INNOLUX DISPLAY CORP.	工程變更客戶通知書 Engineering Change Notices to Customer	保管單位 Storage	AVQA/ CS
		保存年限 Retention Period	3 年

EE101IA-01D 設計變更
EE101IA-01D Design Change

- 1.生產廠區移轉&材料EOL
2. PCBA板增加定位孔及dummy pin

1. Production factory transfer & Component EOL
2. PCBA add alignment mark & dummy pin

PCB Connector

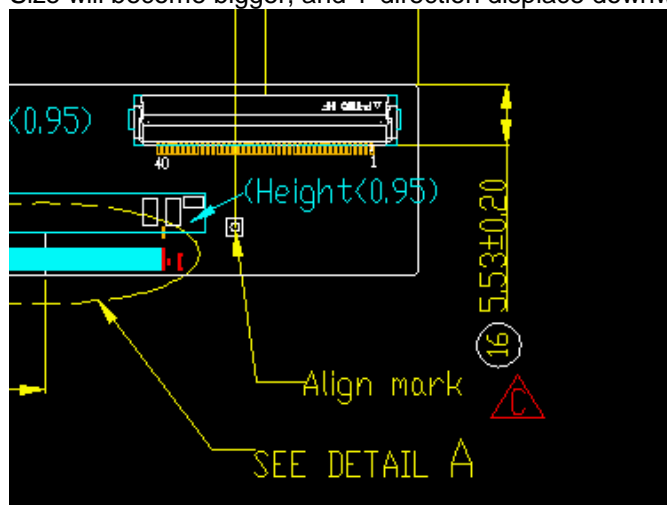
尺寸會變大，Y 方向向下移動 1.78mm

Size will become bigger, and Y-direction displace downward 1.78mm

PCBA 板增加定位孔

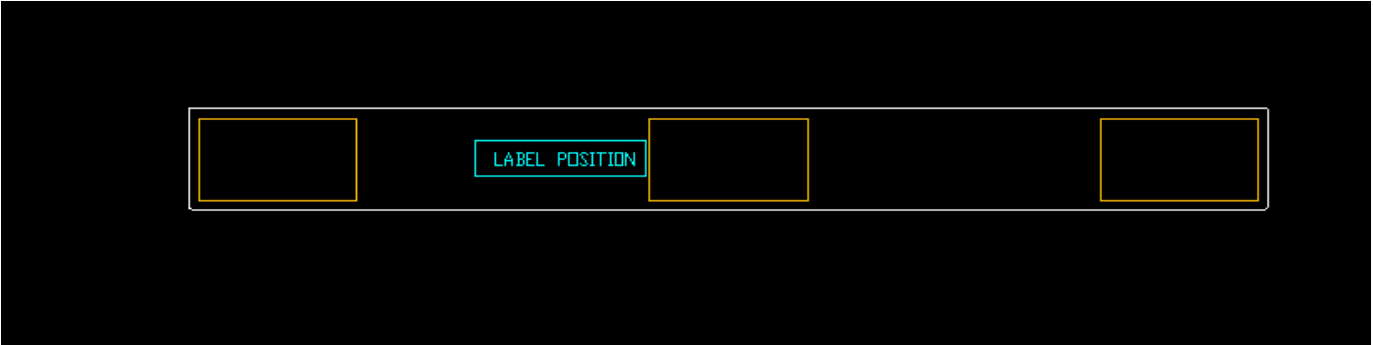
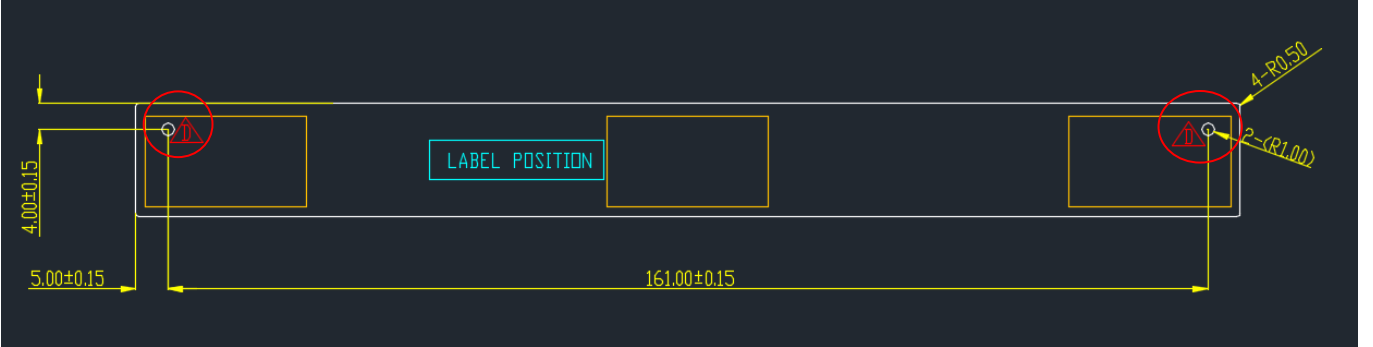
左右各增加一個定位孔，以改善廠內製程良率

Add alignment mark at left & right side for improving process yield.

PCBA 板增加 dummy pin

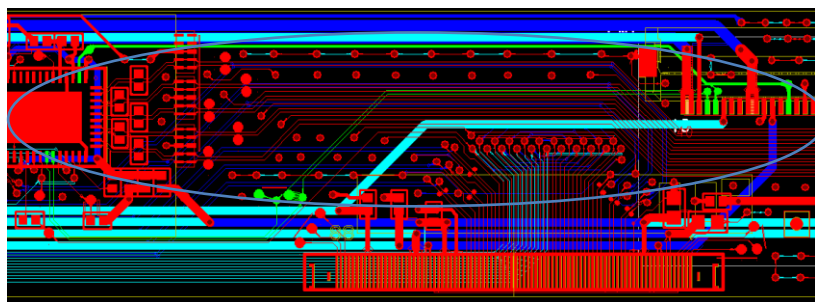
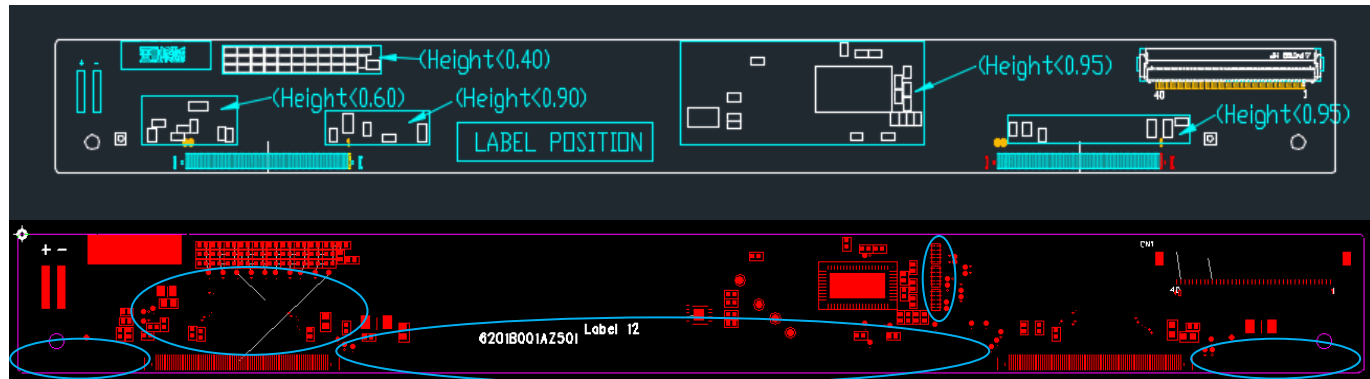
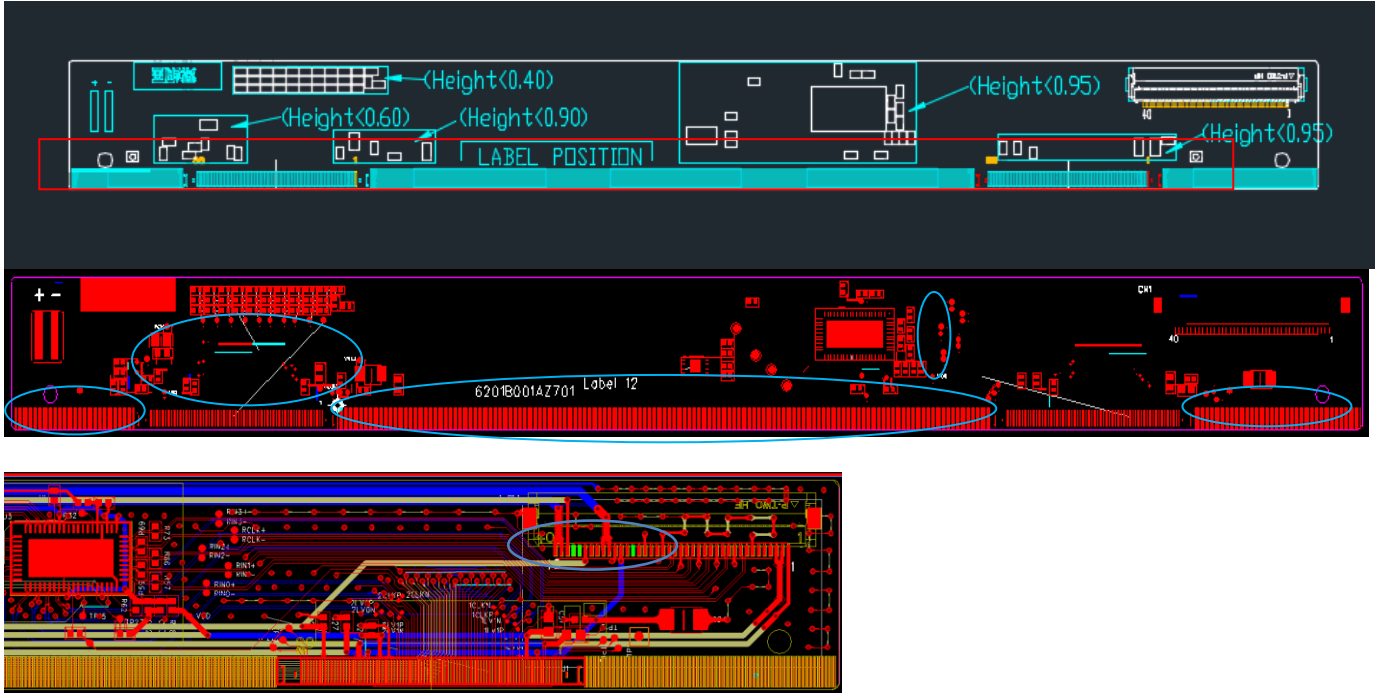
增加dummy pin，調整測試點，移除部份走線及焊盤，更新絲印

Add dummy pin ,adjust test pad , remove some pad and traces , update silk seal
